ATTACHMENT 4 TO AEP:NRC:1067
PROPOSED REVISED TECHNICAL SPECIFICATION PAGES

O. C. COOK - UNIT 1.

FIGURE 3. 2-3 $K(Z)$ - Normalized F sub $Q(z)$ as a function of Core Height

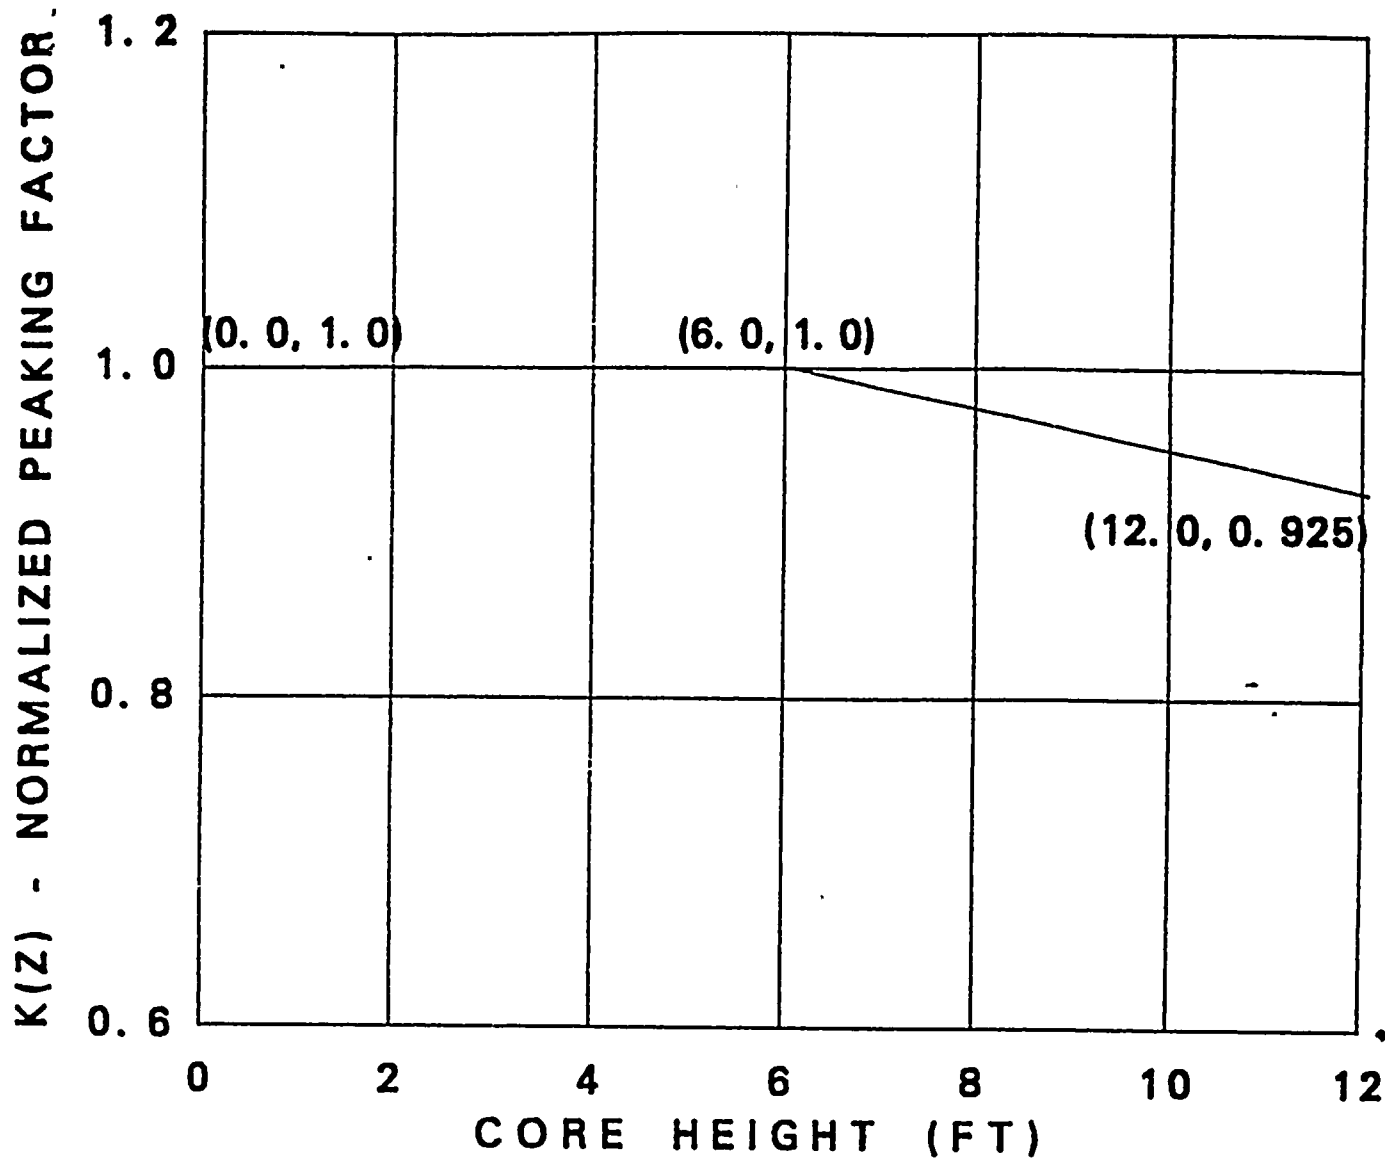
3.2.2 $F_Q(Z)$ shall be limited by the following relationships:

$$F_Q(Z) \leq \frac{[2.15][K(Z)]}{P} \quad P > 0.5$$

$$F_Q(Z) \leq [4.30] [K(Z)] \quad P \leq 0.5$$

$K(Z)$ is the function obtained from Figure 3.2-3.
